Planning and Development Department
Land Use Planning Division

SUBJECT: Public Hearing: Ashby BART West Lot Transit-Oriented Development
Objective Design Standards

Table 1. Summary of Key Changes from the Preliminary ODS to the Revised ODS (Part II)

REVISED Ashby BART West Lot Objective Design Standards (ODS) –September 2026
EXHIBIT A

~~Figure 4-Figure 3. Active~~ Ground-Floor ~~Use~~ Requirements: ~~Active Uses and Other Publicly Accessible Non-Residential Uses~~

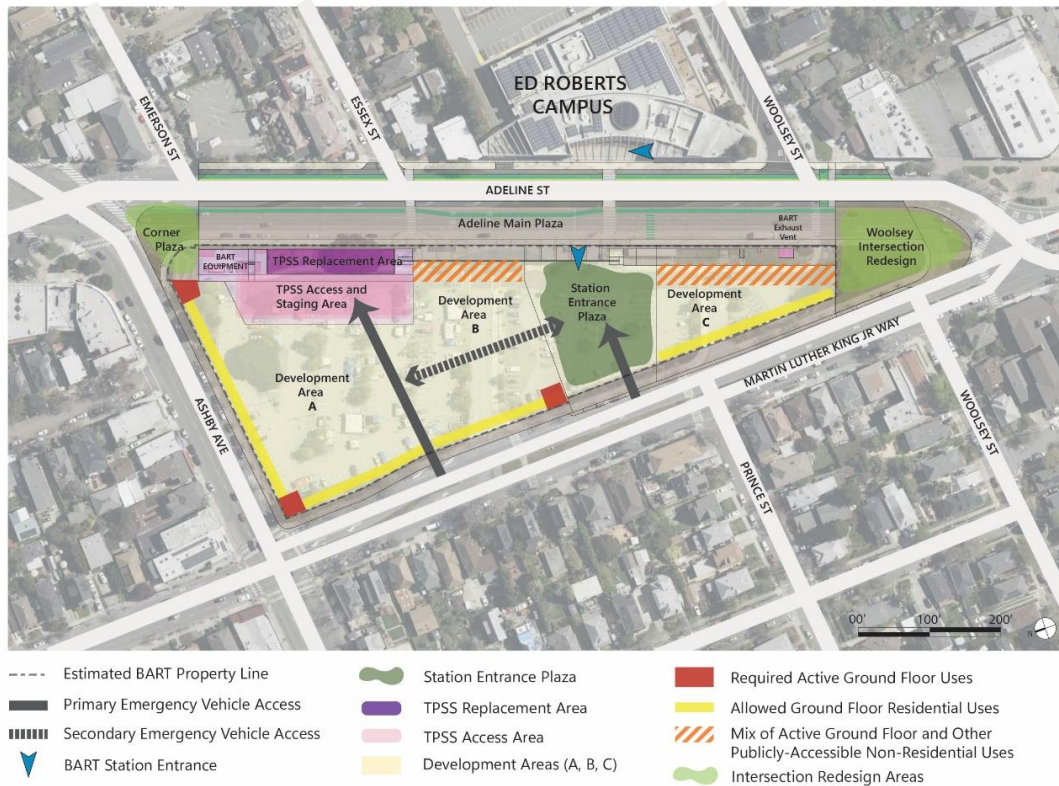
Active Ground Floor Uses – Locations	Required R-BMU-defined “active commercial uses” at the Ashby/Martin Luther King Jr. Way (“MLK”) and Ashby/Adeline corners with a minimum floor area of 1,500-square feet, as well as along at least 40% of specified frontages along the Adeline Main Plaza where buildings provide at-grade connections. Required spaces to be designed as restaurant-ready.	Revised: Focuses required Active Uses in spaces that must be designed as restaurant-ready at three locations: Ashby/MLK, Ashby/Adeline (where applicable), and MLK/Station Entrance Plaza. Reduces the minimum Ashby corner spaces from 1,500 to 1,200 square feet and establishes a minimum of 2,400 square feet at the MLK/Station Entrance Plaza corner.	Focuses active commercial requirements at key corner locations while providing greater flexibility along Adeline Street.
		Revised: Along the Adeline Street frontage (where applicable), Allows either Active Uses or Other Publicly Accessible Non-Residential Uses along the Adeline frontage, with minimum frontage requirements of 60% in Development Area B and 40% in Development Area C.	Broadens the range of community-serving and publicly accessible uses that may satisfy the frontage requirement along Adeline Street, providing greater flexibility while maintaining a substantial level of ground-floor activation.

1. ~~Ground floor~~ Residential ~~uses~~ ~~Uses~~ are permitted ~~along Ashby Avenue and MLK Jr Way~~ where ~~Active Uses or Other Publicly-Accessible Non-Residential Uses are required pursuant to Section 1.1.1~~ active uses are not required on the ground floor in the above standards.

Figure 8:-Diagram of MLK Jr. Way - South of Station Entrance Plaza

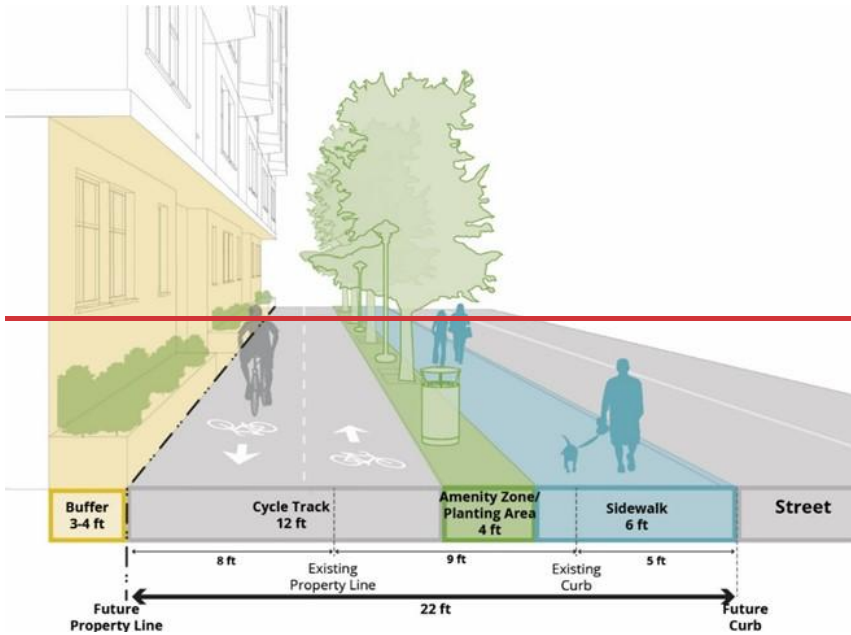
2. Public Realm			
Sidewalk Design	Established sidewalk design dimensions along Ashby Avenue and Martin Luther King Jr. Way, north and south of the Station Entrance Plaza.	Retained: Sidewalk dimension requirements for Ashby Avenue. Removed: Sidewalk dimension requirements for Martin Luther King Jr. Way – south of the Station Entrance Plaza that required a 2-way cycle track at the sidewalk level. Revised: The same sidewalk dimension requirements apply for Martin Luther King Jr. Way (north or south of the Station Entrance Plaza). Different street configurations will apply as follows: North of the Station Entrance Plaza, MLK Jr. Way will include a parking/loading lane and two travel lanes. South of the Station Entrance Plaza, MLK Jr. Way will include a two-way on-street protected cycle track and two lanes of traffic. It is not anticipated that the existing curb line to median dimension will change along Martin Luther King Jr. Way (MLK Jr. Way). Refined: Allows exceptions to street dimensions where existing trees outside the right-of-way are retained and clarifies that subsurface design requirements apply to new trees.	Comprehensive analysis of pedestrian, bicycle and overall station access and operations that minimize conflicts are underway as part of the Ashby West Lot Station Access Plan. Through this effort, an alternative street cross section has been developed that locates the two-way cycle track on street as opposed to at the sidewalk level. Provides flexibility where existing trees are preserved and clarifies the applicability of subsurface design requirements.

Figure 9.-Conceptual Elevation of Development Area B facing the Station Entrance Plaza

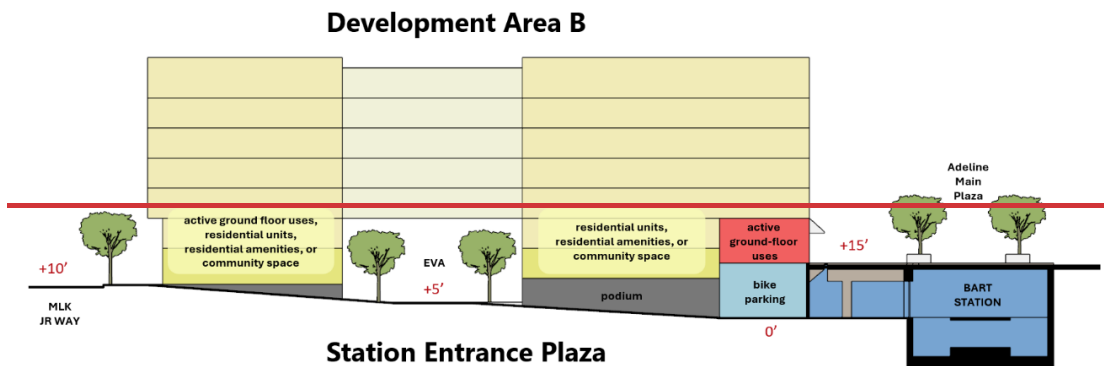
~~2.—Development Area B. Habitable spaces such as active ground-floor uses, residential units, residential amenity spaces, and community spaces shall front the Station Entrance Plaza to create an activated building frontage (see Figure 9)~~

Figure 7. Diagram of Access Drive Required Dimensions through Development Areas A and B (Illustrative Concept)

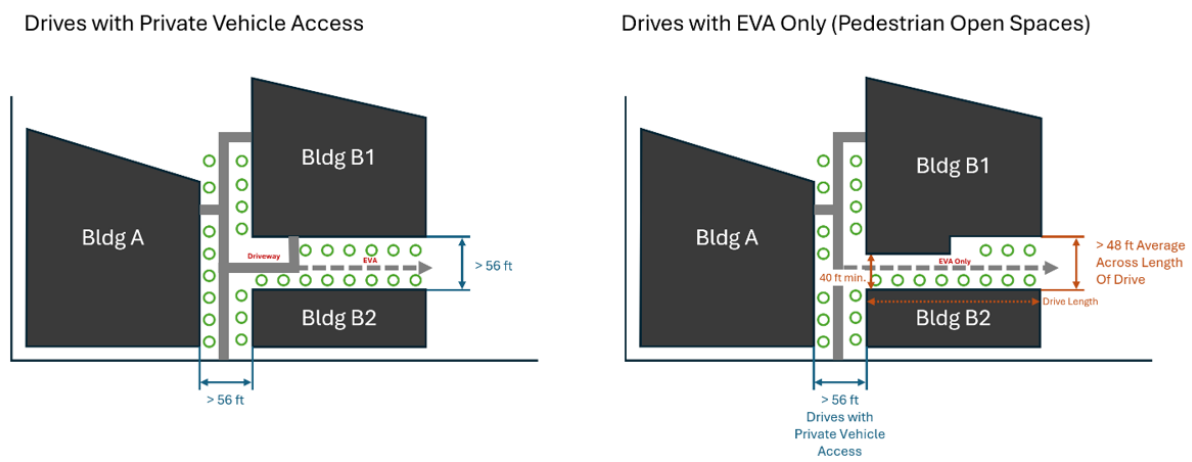
Internal Access Drives and Emergency Vehicle Access	Required a minimum 60-foot building-to-building width for access drives, along with Fire Department-approved EVA widths and landscaping and frontage standards.	Revised: Reduces the required building-to-building width to 56 feet for access drives with public vehicle access. Drives used only for emergency access and otherwise limited to pedestrian/non-motorized use may have a 48-foot average width and 40-foot absolute minimum. Added more specificity for new tree planting requirements and/or public art of landscaping.	Provides greater flexibility for site design, particularly for access drives that function primarily as pedestrian/non-motorized connections while accommodating emergency access. Added street tree, public art and/or landscaping requirements to enhance the streetscape and pedestrian environment.
Internal Access Drive Landscaping	Required trees on both sides of access drives to reinforce their pedestrian character.	Refined: Clarifies tree requirements and allows other planting or public art where trees cannot be provided on both sides of an access drive.	Provides flexibility where tree planting is infeasible while maintaining the intent of enhancing the pedestrian experience and buffering parking and utility areas.

~~1-a)~~ Access drives with public vehicle access shall have a minimum building-to-building width of ~~60~~ 56 feet. (see Figure 10)

1. Access drives (see Figure 7)
 - a) Access drives with public vehicle access shall have a minimum building-to-building width of 56 feet.
 - b) Access drives used solely for emergency vehicle access shall have a minimum average building-to-building width of 48 feet and an absolute minimum building-to-building width of 40 feet.

Figure 11. Figure 8. Diagram of Major Breaks and Vertical Façade Articulations

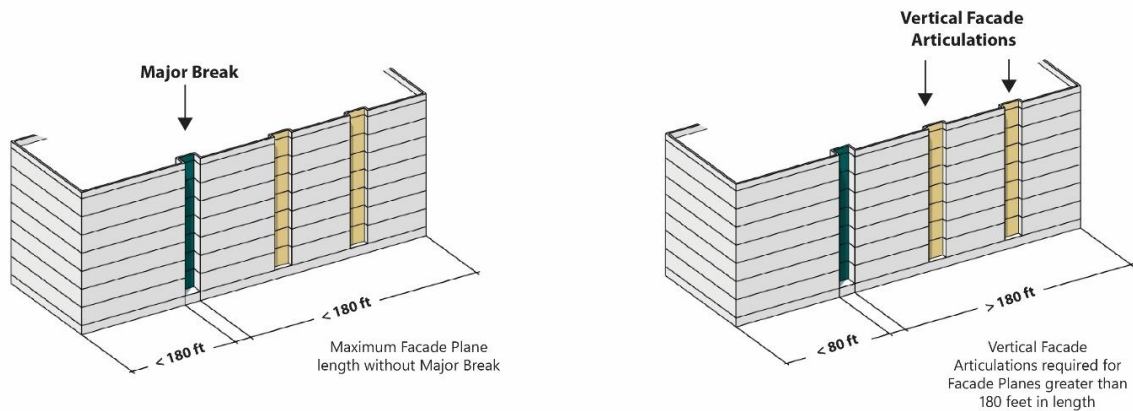
Topic	Preliminary ODS	Revised ODS	Rationale for Revision
<i>and Facade Lengths – cont'd)</i>	For all frontages, including Ashby Avenue, Facade Planes were limited to 160 feet unless a Major Break was provided. Major Breaks were required to be at least 6 feet wide and 6 feet deep, with a minimum horizontal area of 50 square feet. <i>(Note: The Preliminary ODS inadvertently referred to “all other frontages.” The Facade Plane and Major Break requirements were intended to apply to all frontages, including Ashby Avenue.)</i>	Revised: Increases the maximum Facade Plane length from 160 to 180 feet for all frontages and reduces the minimum dimensions for Major Breaks from 6 feet wide by 6 feet deep and 50 square feet in area to 5 feet wide by 3 feet deep and 36 square feet in area.	Provides additional design flexibility on a highly constrained site while maintaining standards to break up long building facades and large building masses.

~~2-3. A Facade Planes is the portion of a building facade located between building corners. Building Break or Major Break. Facade Planes~~ shall not exceed ~~160-180~~ feet in length, ~~measured from a building corner or major building break, see Figure 11.~~

3. A Facade Plane is the portion of a building facade located between building corners, Building Break or Major Break. Facade Planes shall not exceed 180 feet in length.
4. A Major Break shall have a minimum width of 5 feet, minimum depth of 3 feet and a minimum horizontal area of 36 square feet.
